**PLANNING & ZONING BOARD
AGENDA ITEM 6A**

**PLANNING & ZONING BOARD
AGENDA ITEM 6B**

TOPIC: **PUBLIC HEARING** for Lino Lakes Dealership and Offices
1. Conditional Use Permit
2. Site and Building Plan Review

CASE NUMBER: CU2025-0001
SP2025-0005

LINO LAKES DEALERSHIP
OFFICES
7920 LAKE DRIVE, LINO LAKES, MINNESOTA
LANDSCAPE PLAN

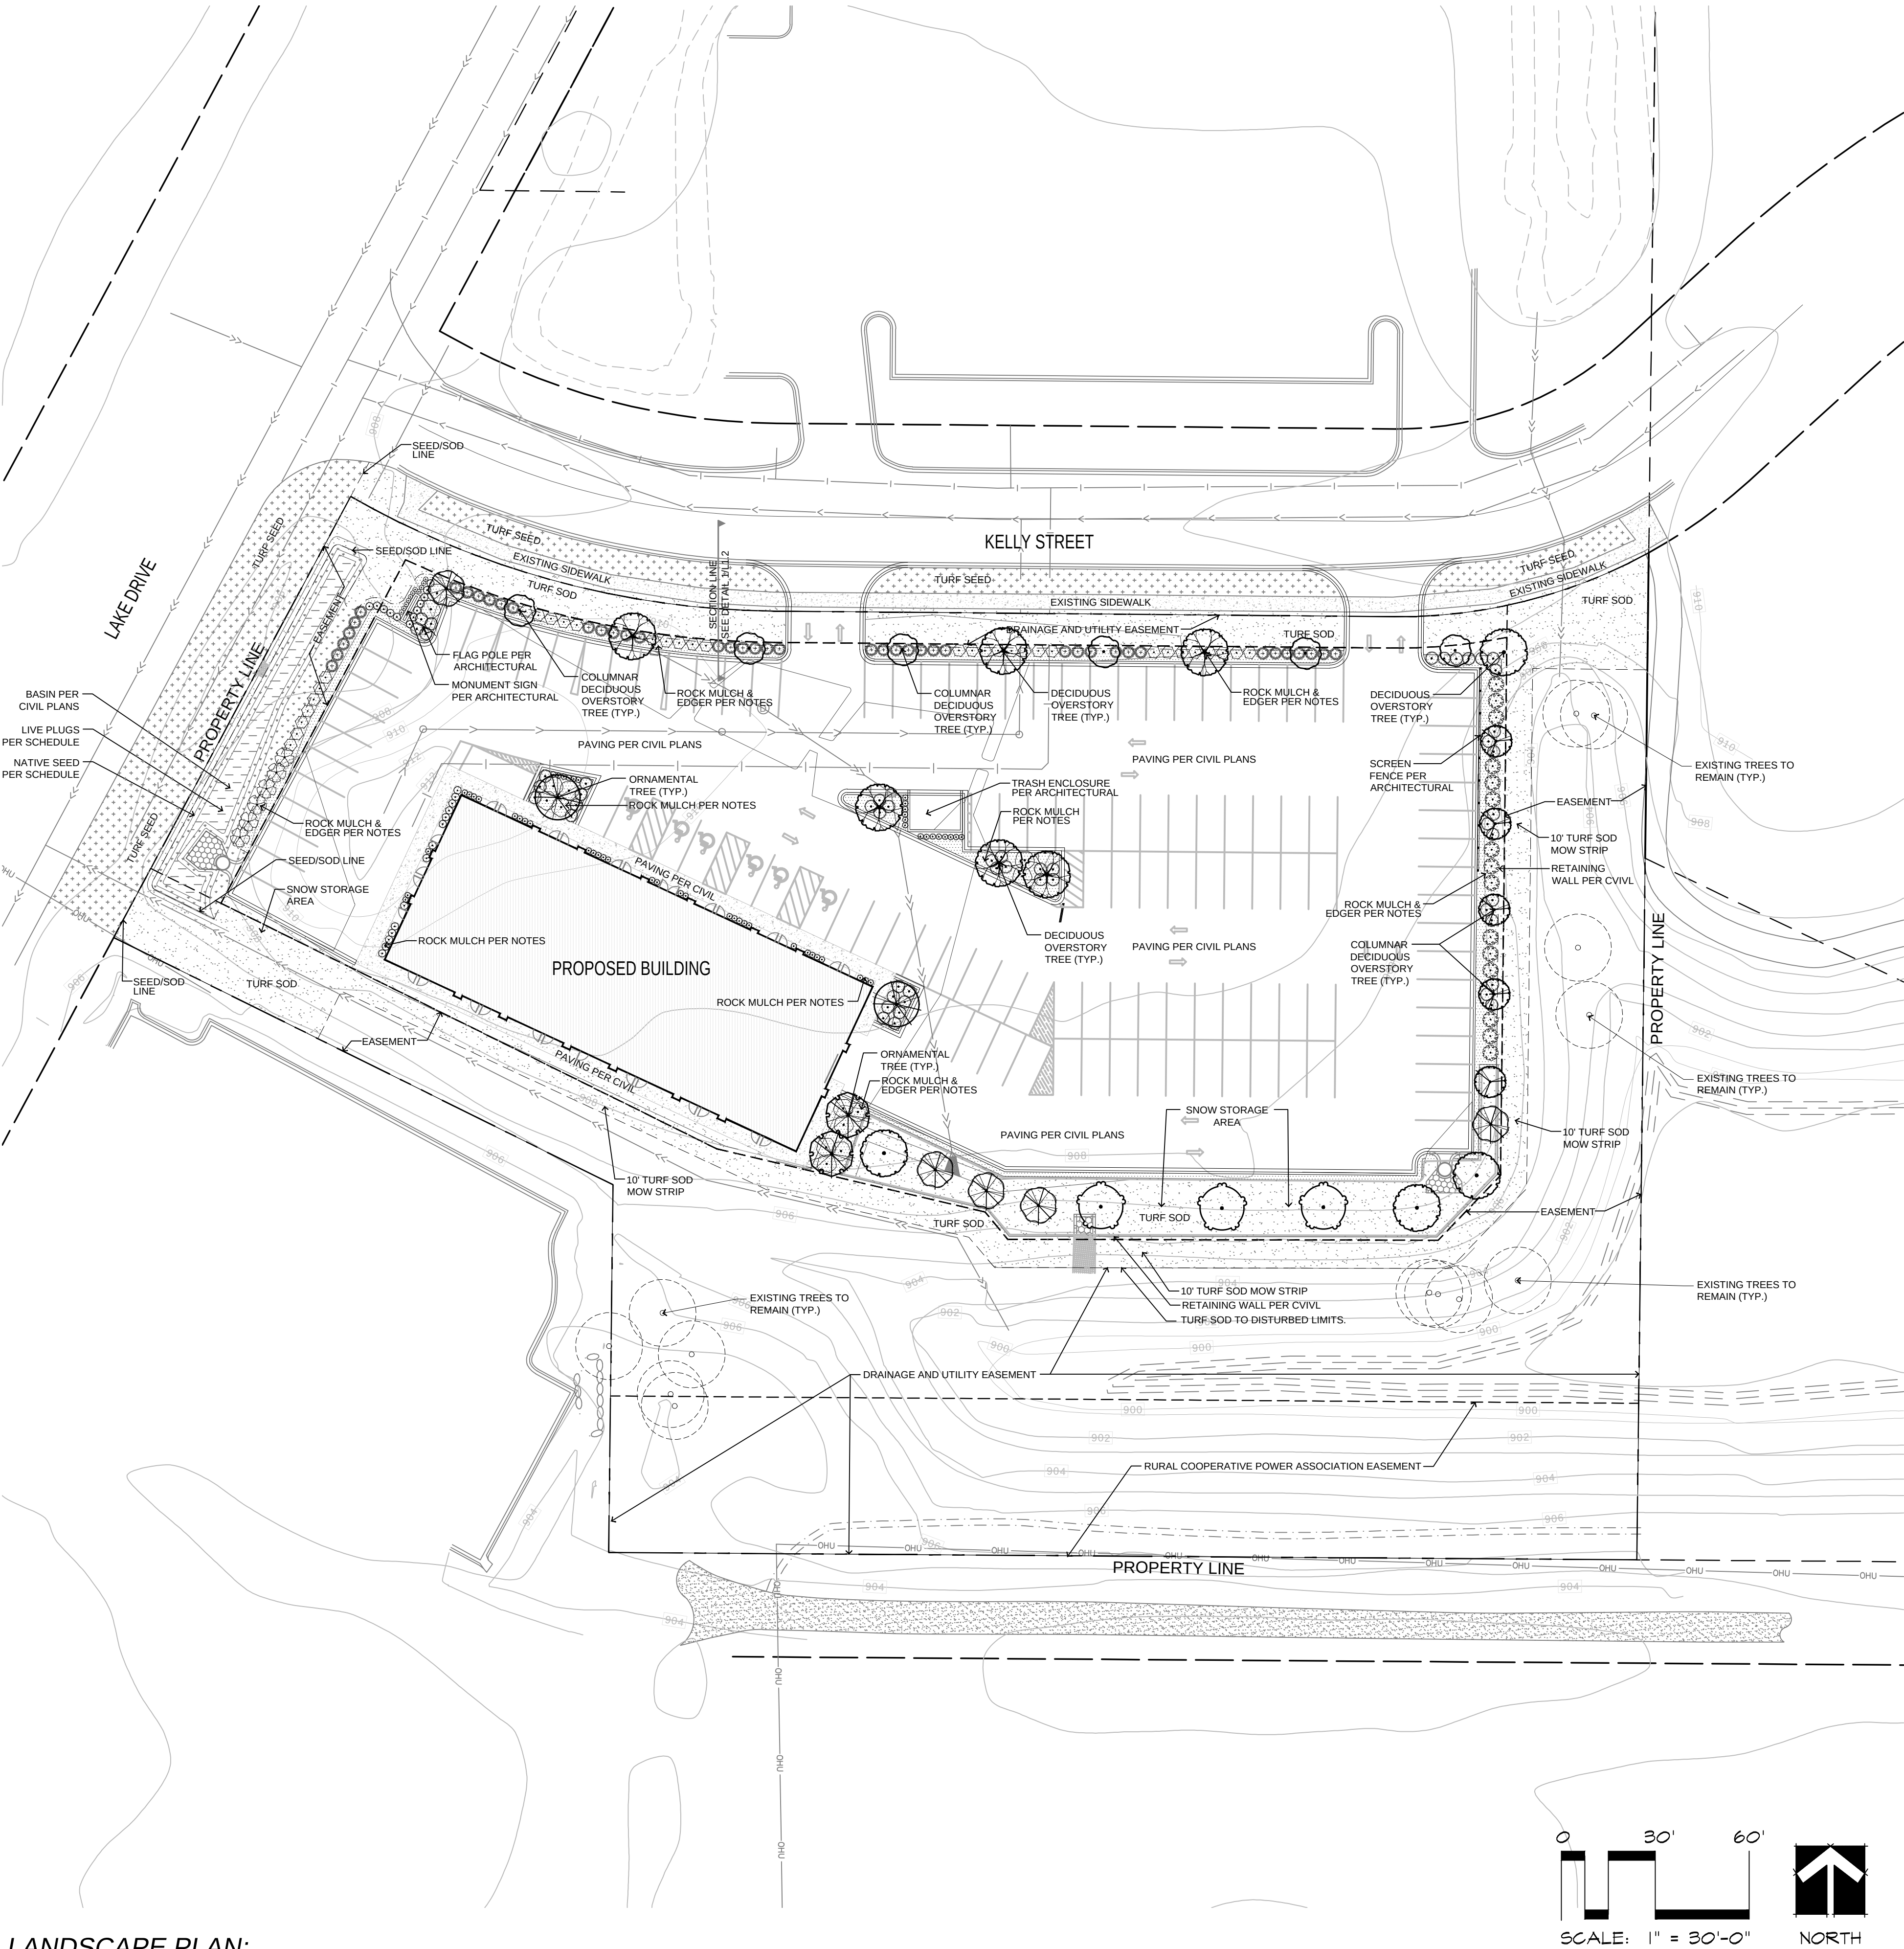
5. Native vegetation must be shown over proposed infiltration BMPs and their side slopes in the landscaping plan.
6. Trees should not be planted in the infiltration basin.

2. Recommend planting native species or low mow fescue adjacent to the parking lot where the site drains to the stormwater bmp.
 - a. Filtration of additional buffer will be beneficial to soil stabilization, pollutant filtration, and wildlife/pollinator habitat.

3. Rock mulch bed for landscaping to be flush with ground level.
4. Remove tree plantings from within the infiltration basin 1 as this will lead to maintenance issues.

- a. Removal of the trees from the basin will likely change the vehicular hardscape coverage calculations
5. Infiltration Basin 1 is being proposed as a snow storage area, staff highly recommends storing snow outside of the basin. Storage within the basin will lead to higher sedimentation rates, increased chloride, and maintenance issues.

COVER SHEET

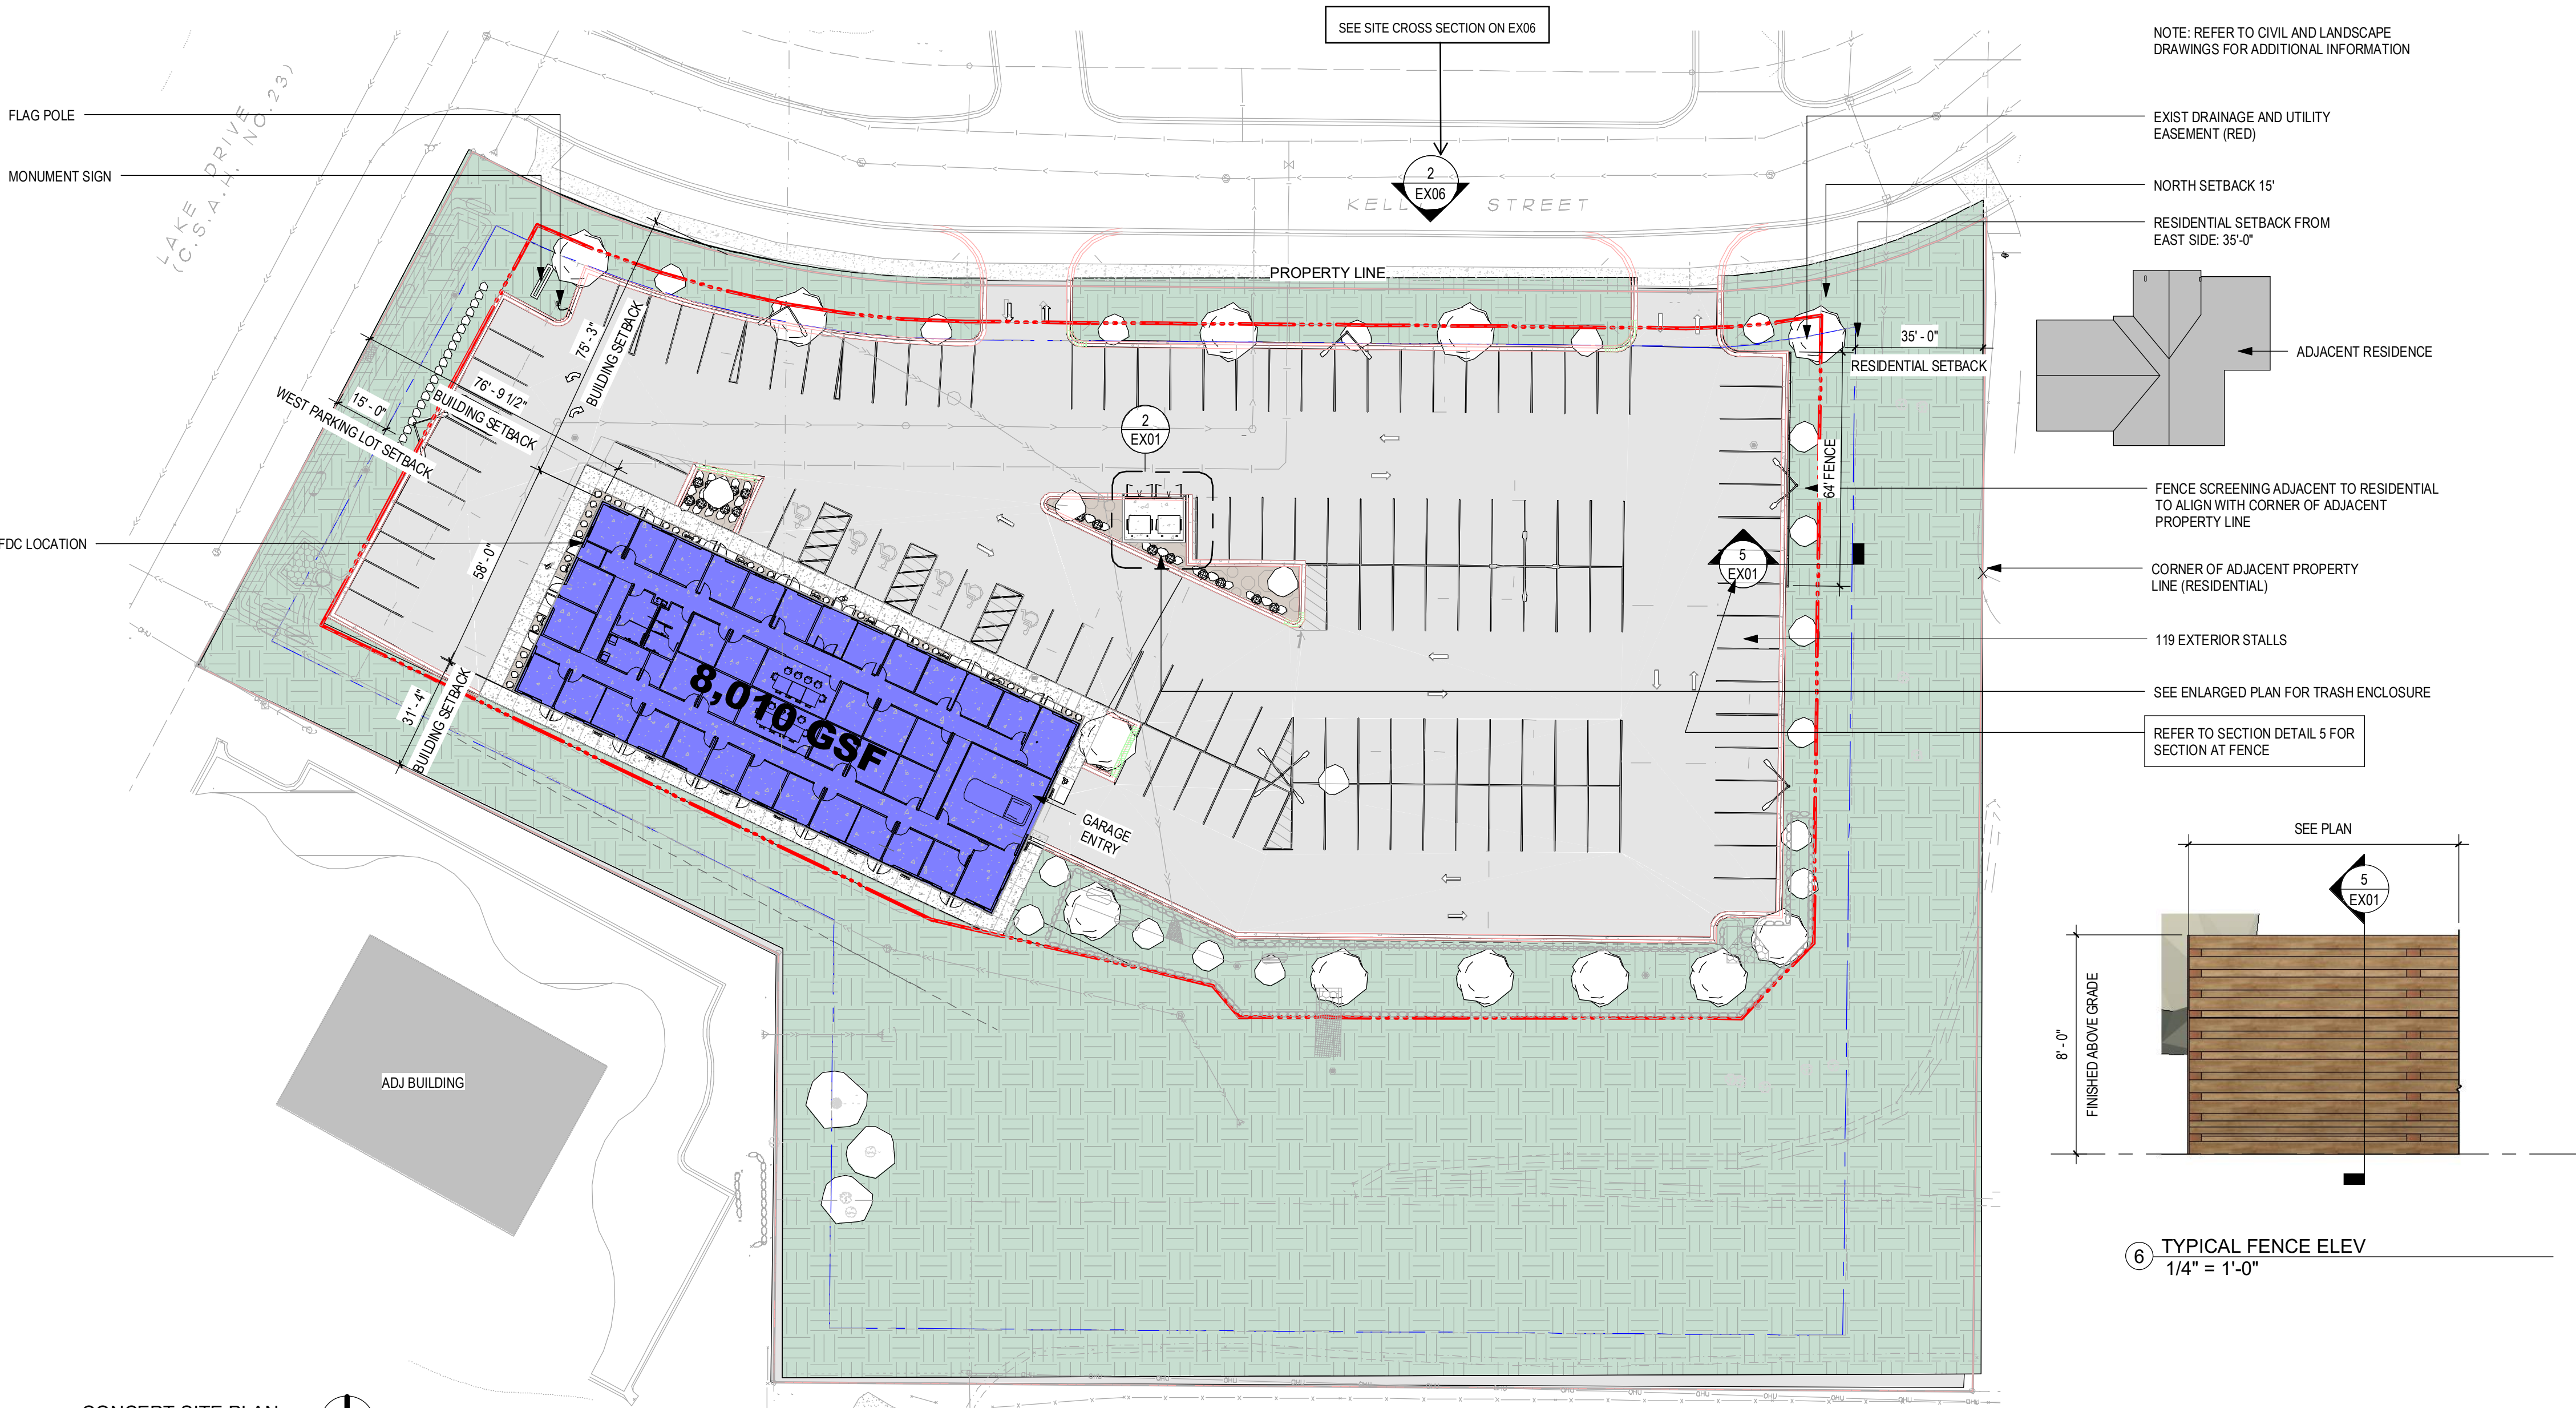
- b. The red and blue lines shall be labeled.
 - c. The 8ft tall screen fence shall extend the full length of the parking lot.
 - d. Under General Site Plan Notes, revise Off-Street Parking Data:

- i. Office space is per floor area, not gross.
 1. Subtract 10% from gross area to calculate floor area.
 2. See Site and Building Plan Review Worksheet

- ii. 8,800 sf does not match site plans.
 - iii. 151,532 sf should be 121,532 sf
10. Photometric Plan and Lighting Fixtures:
 - a. The photometric plan does not meet foot candle requirements and shall be revised.
